ADDENDUM NO. 1

Job No. F70C616E
SAND ISLAND STATE RECREATION AREA
SEWER SYSTEM IMPROVEMENTS
PHASE 2: PUMP STATION 3 RELOCATION & FM 3 REPLACEMENT
Honolulu, Oahu, Hawaii

02/22/21

| APPROVED: | | DRAWING NO. | C003 |

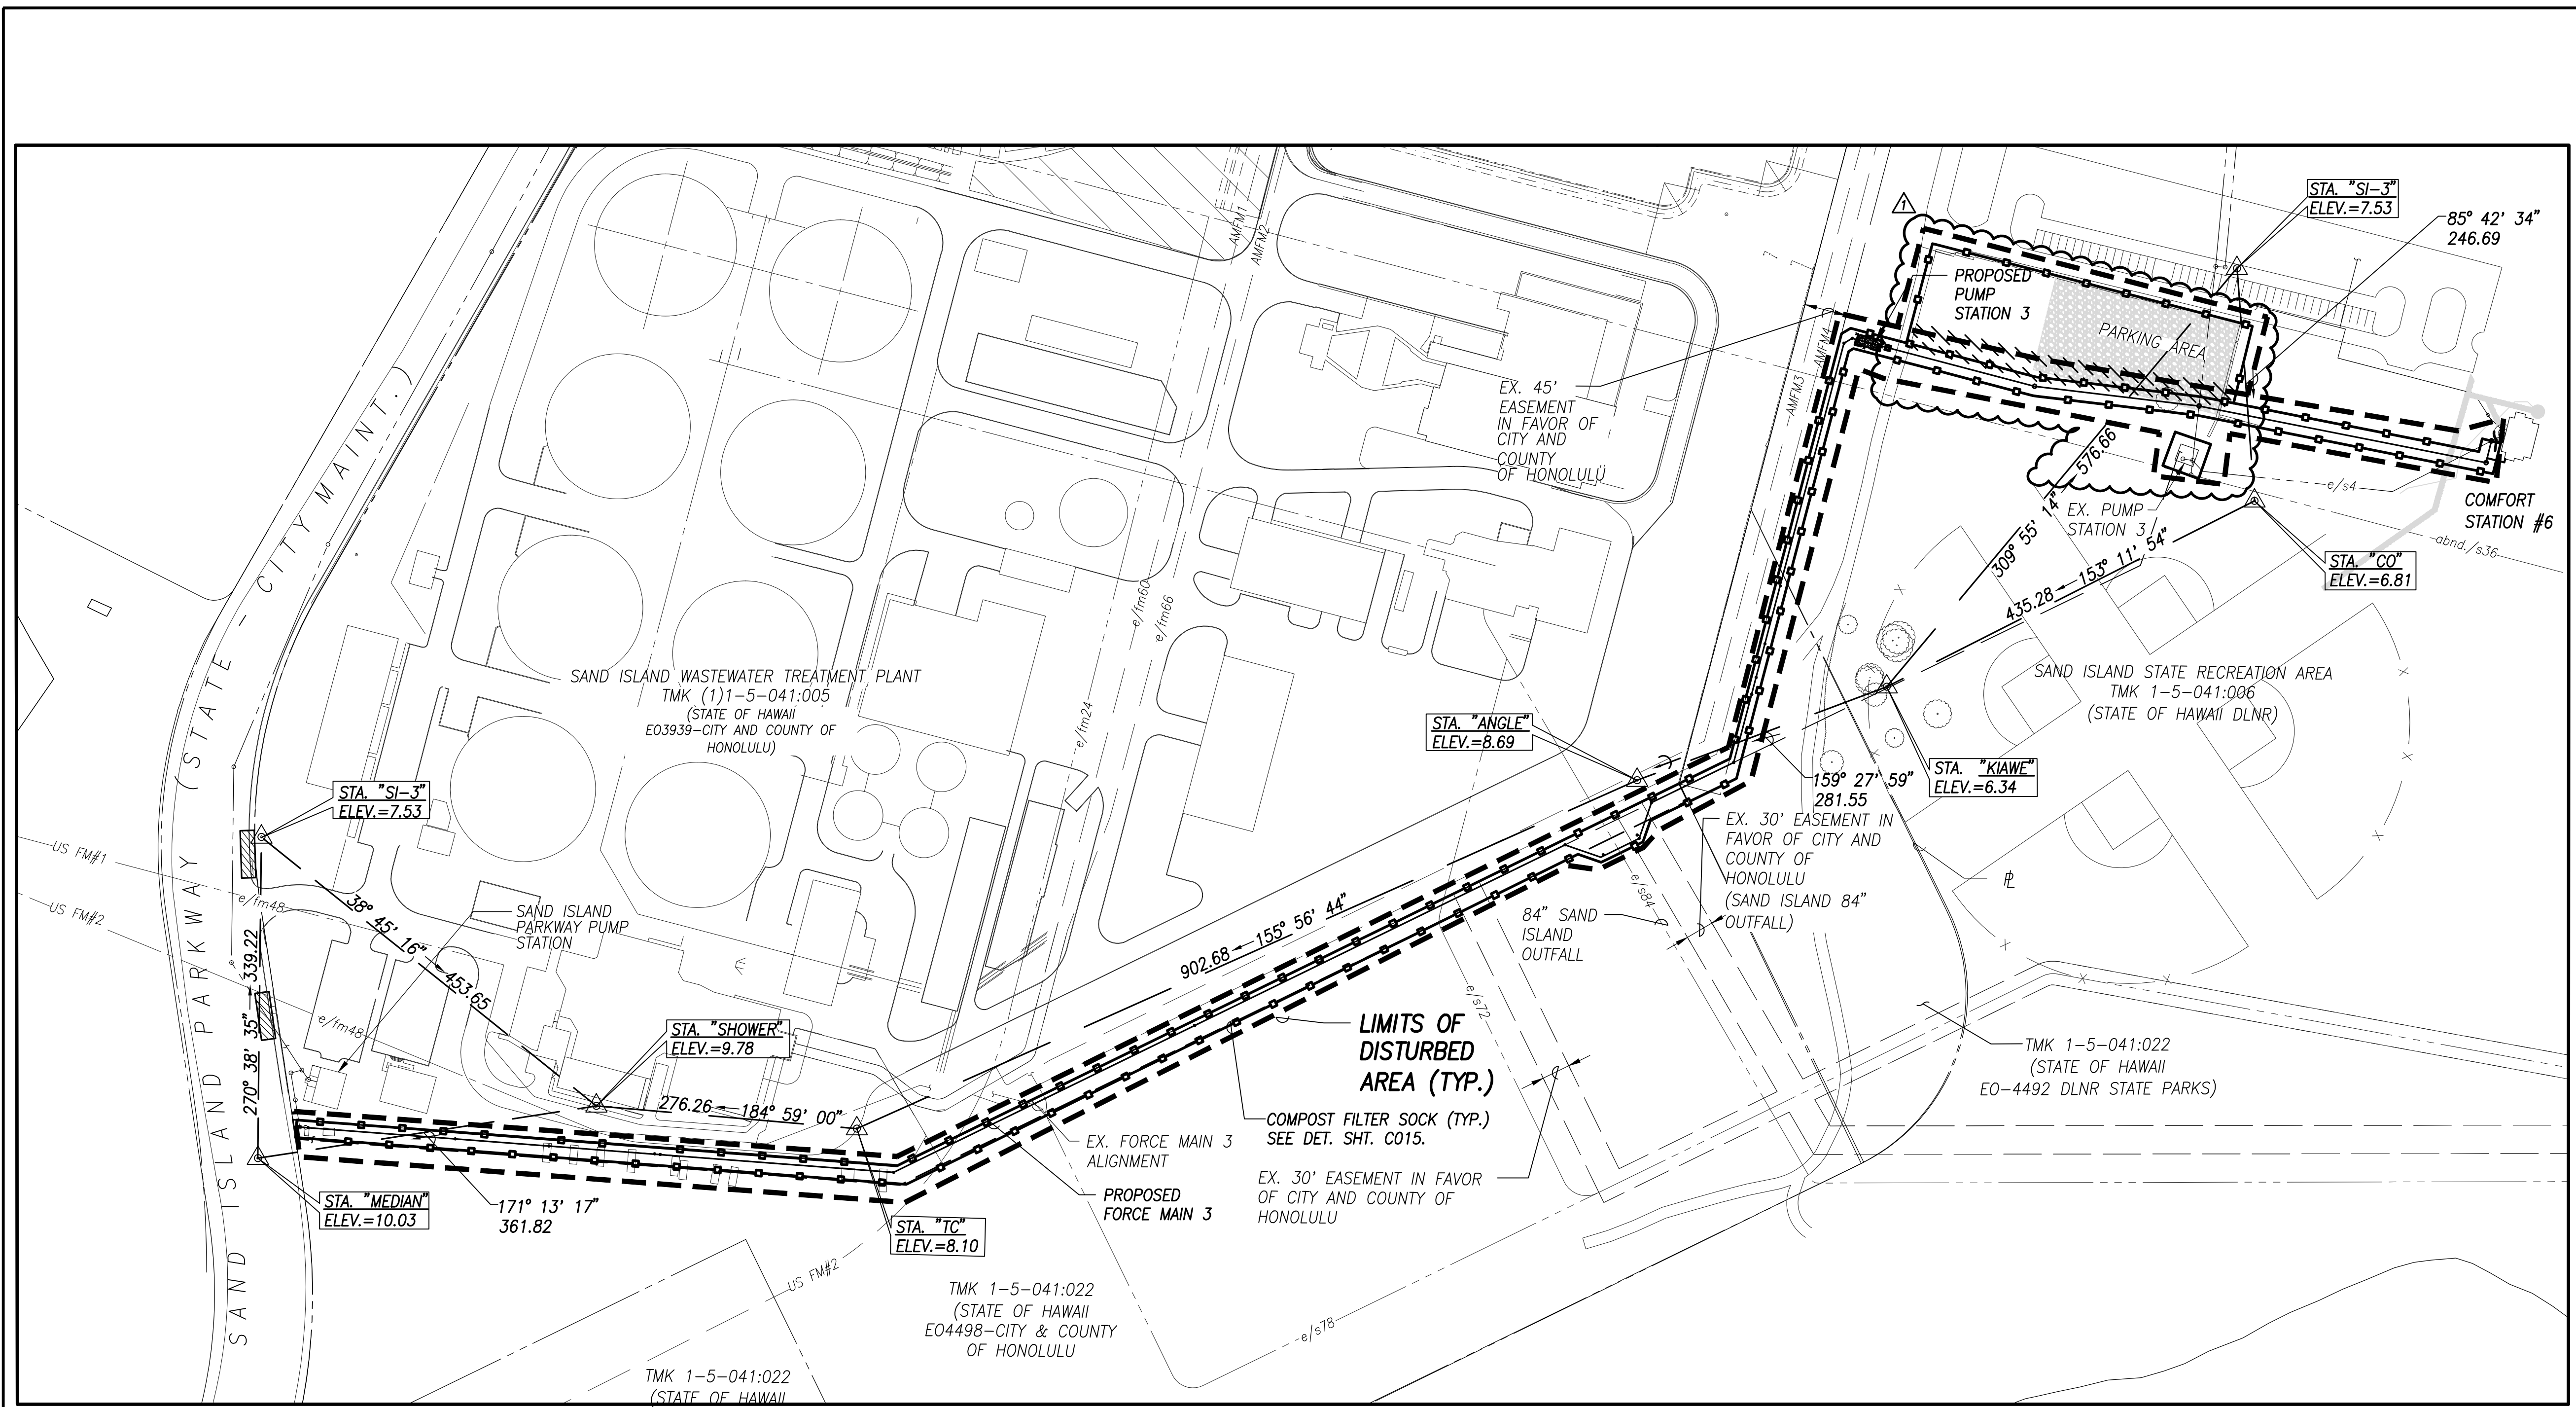
- 1. Sheet C003, “General Site Plan”
 - a. Revised limits of disturbed area.

| APPROVED: | DRAWING NO. C004 |

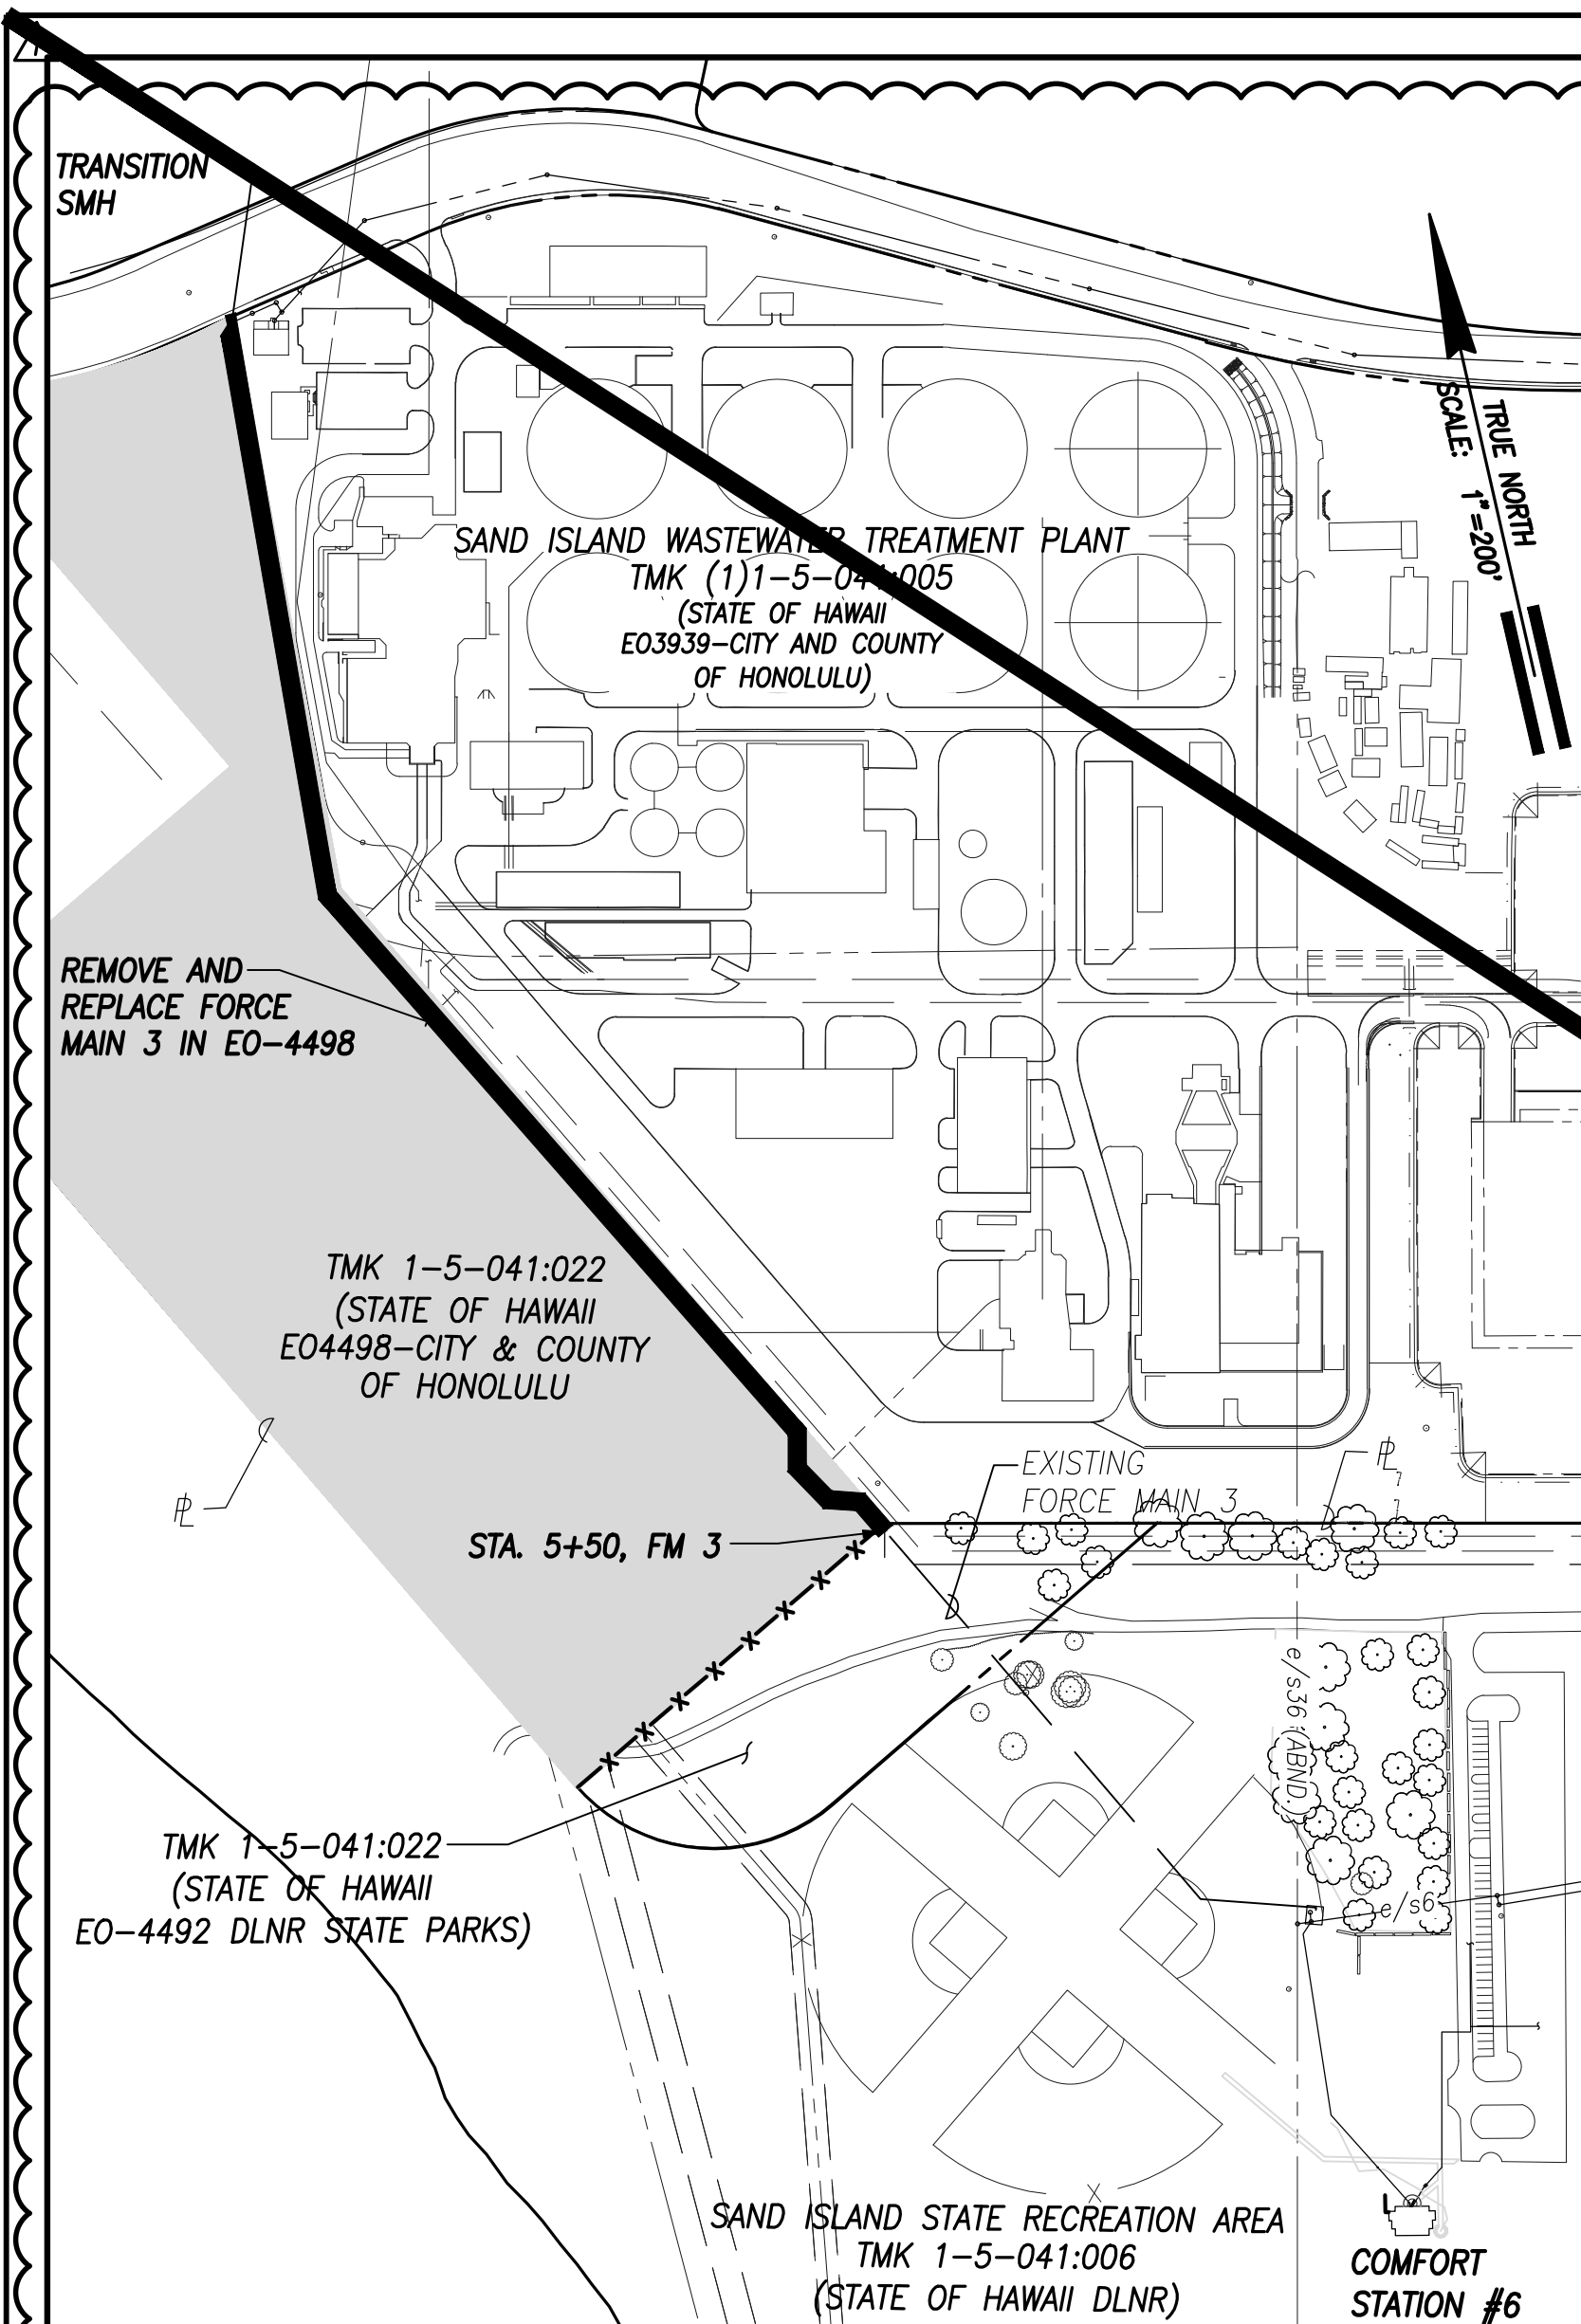
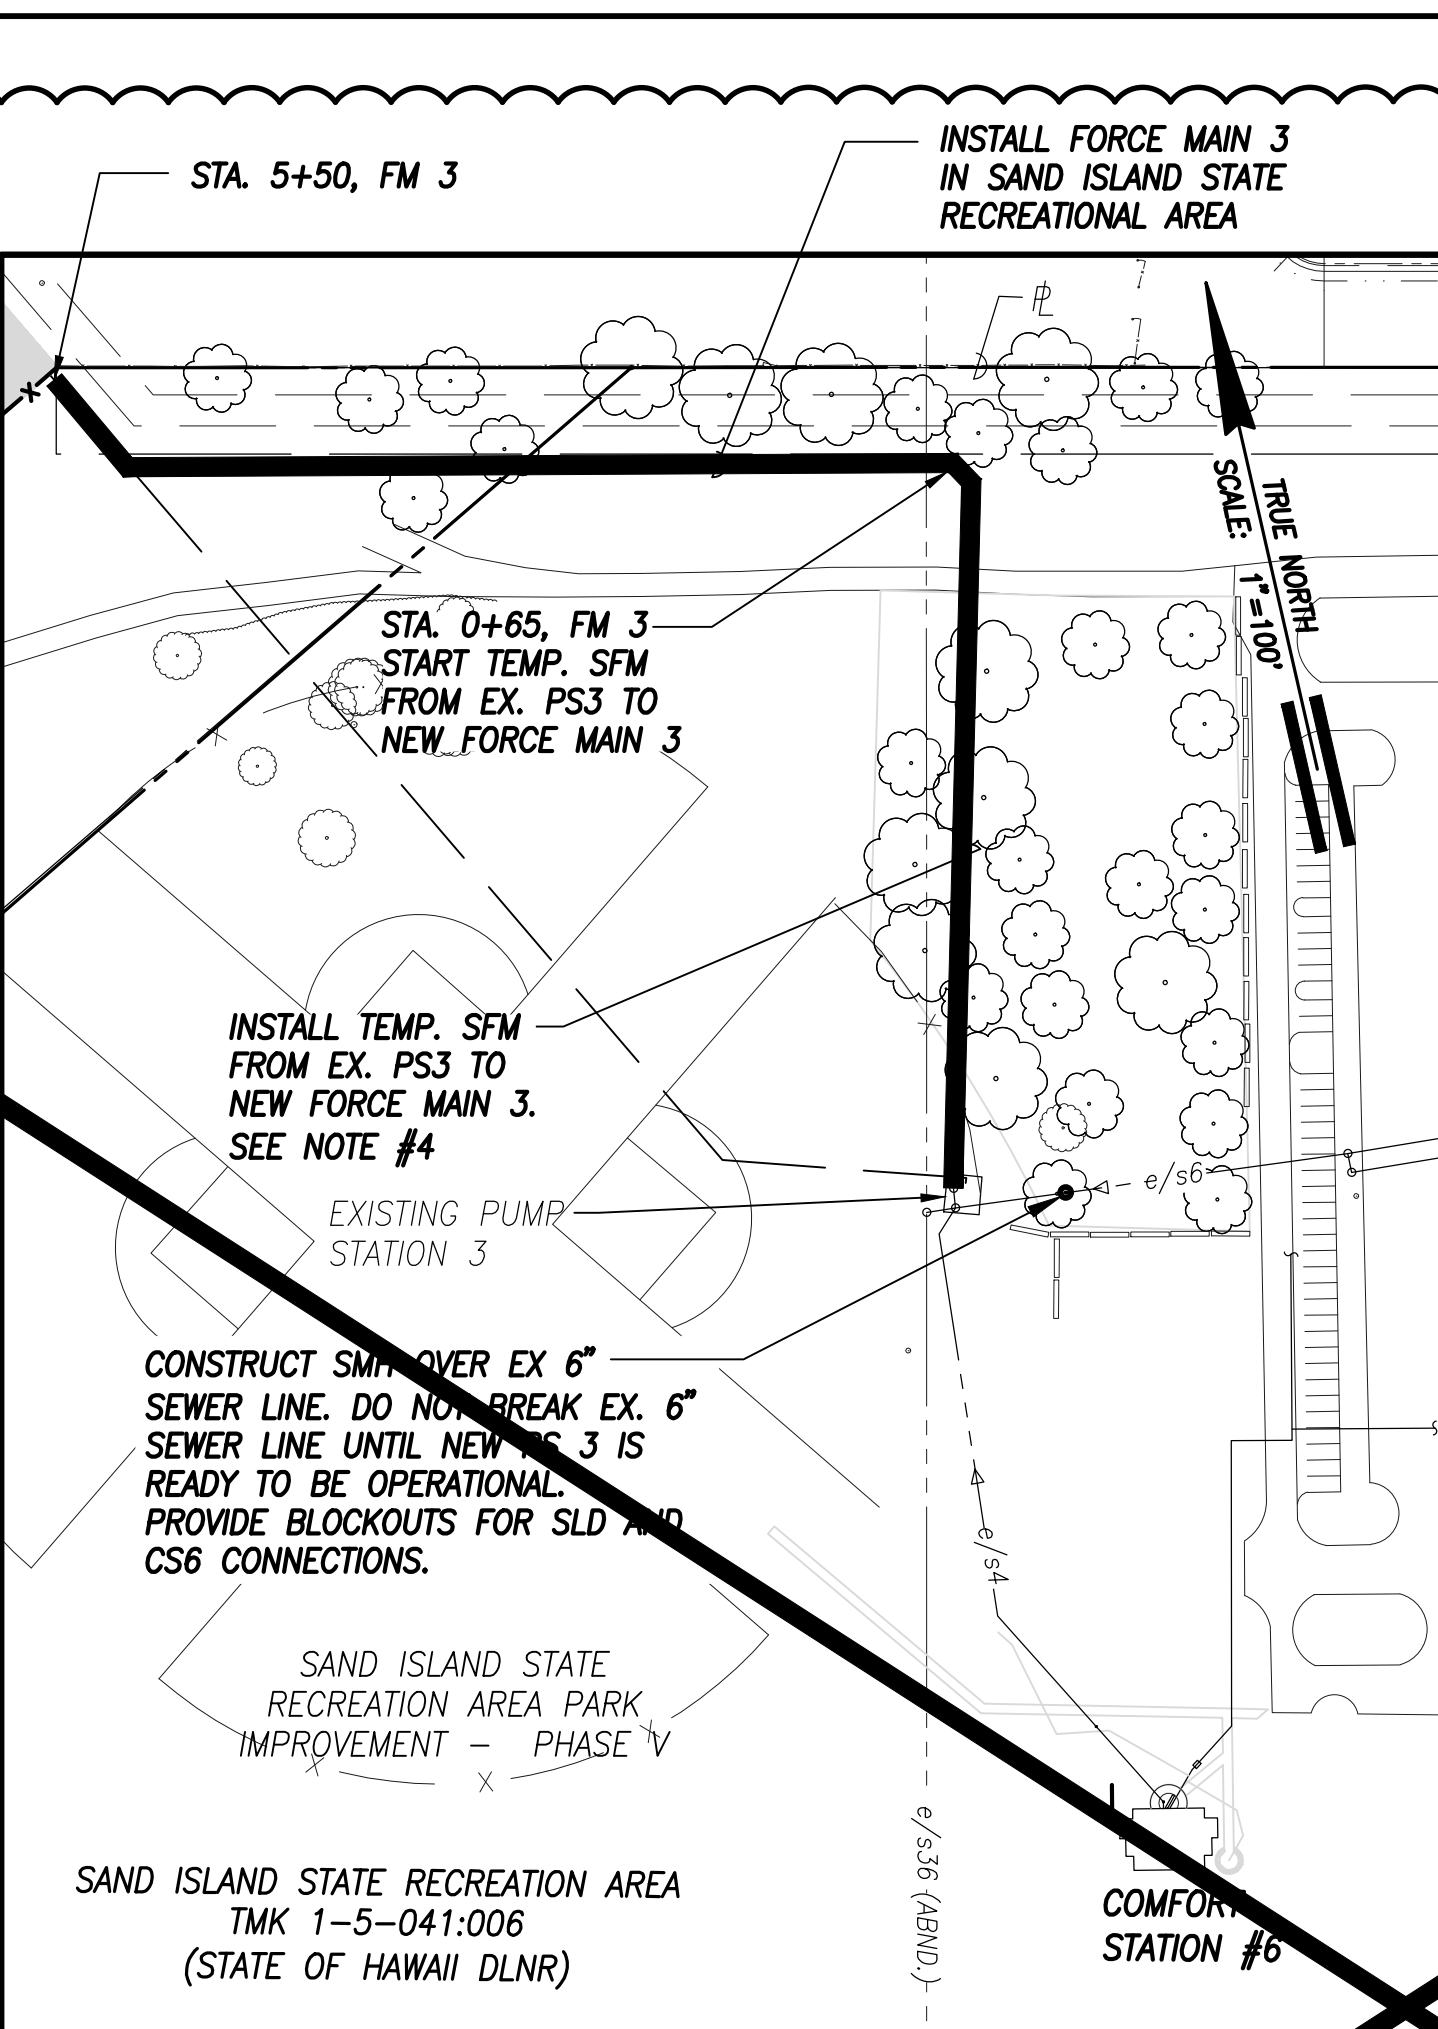
2. Sheet C004, "Erosion Control Plan"
 - a. Revised limits of disturbed area.
 - b. Revised compost filter socks alignment.
